INTERIM CHANGE REQUEST

Plan Title/Rev. Unit 2 ASME Sec XI ISI Program Plan Rev 1 ICR No. ISI-2R1-01

Component: Table 9 of section 5.0RHR system boundary drawing of section 2.0

RESIDUAL HEAT
REMOVAL SYSTEM
SHEET 1 OF 2

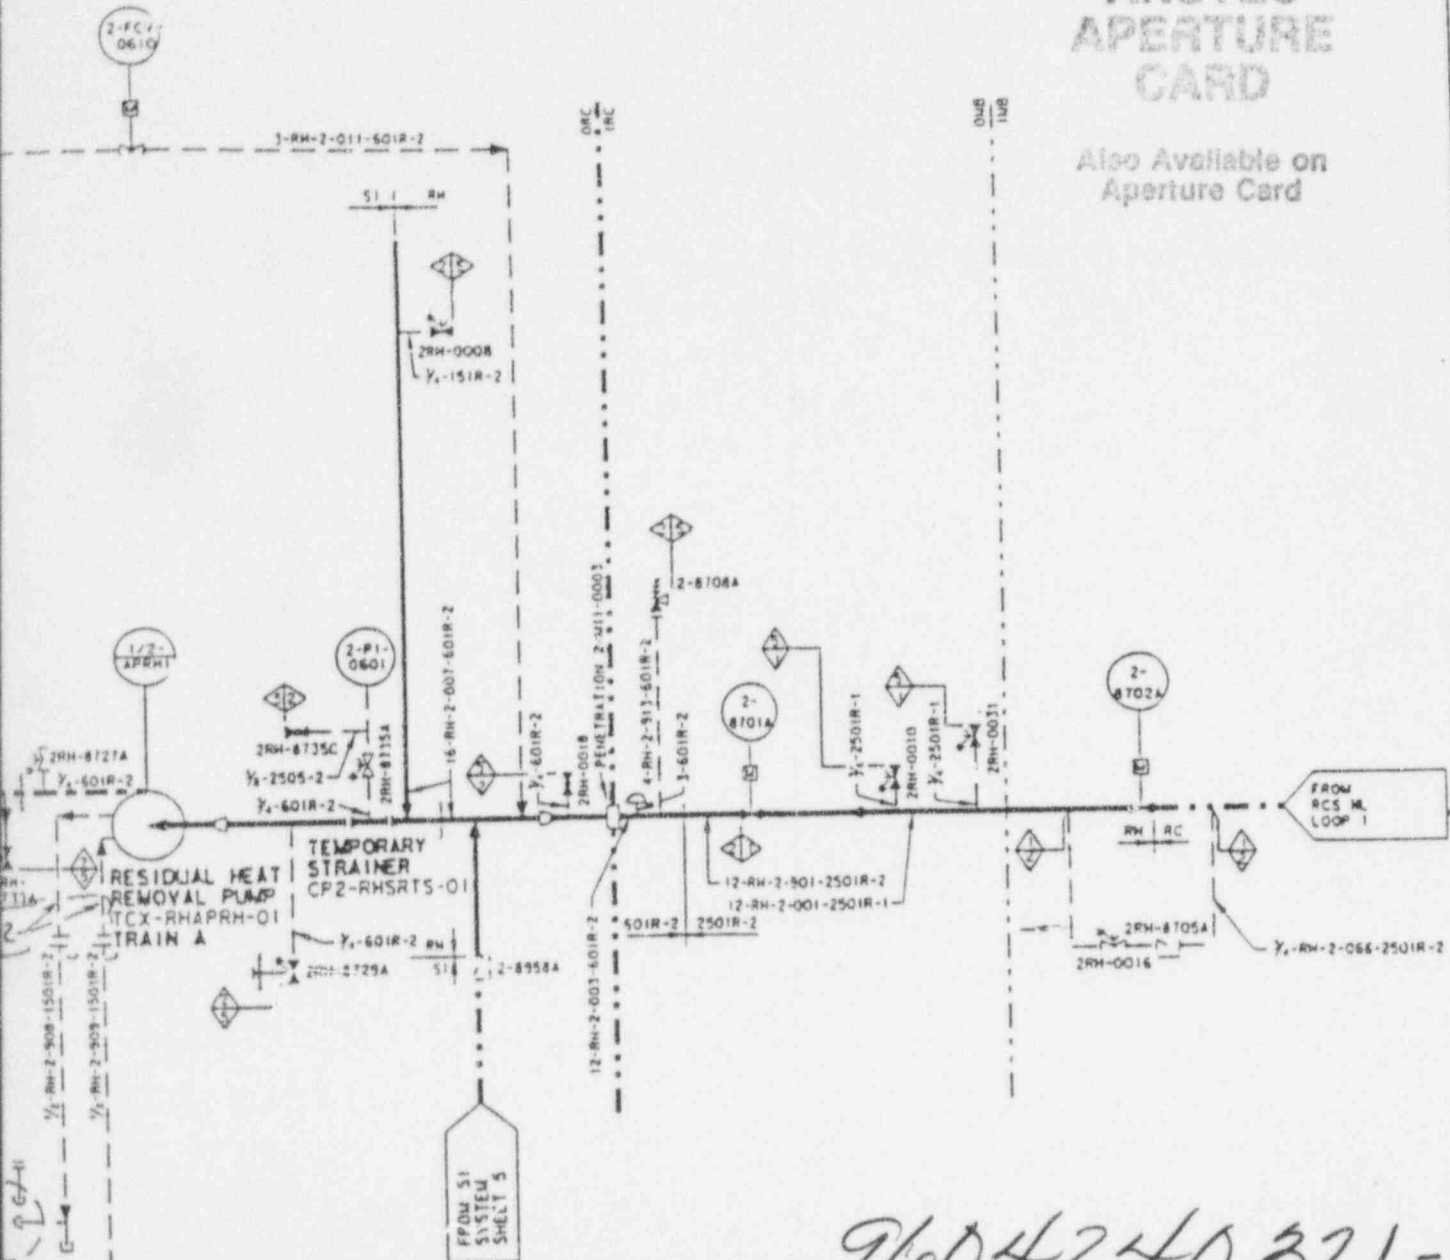
Incorporation changes made to the RHR system
per D.M. 94-45

Revise boundary drawings to reflect as built condition

• Replace RHR system boundary drawings sht 1 of 2 and 2 of 2
in Section 2.0 with attached drawings
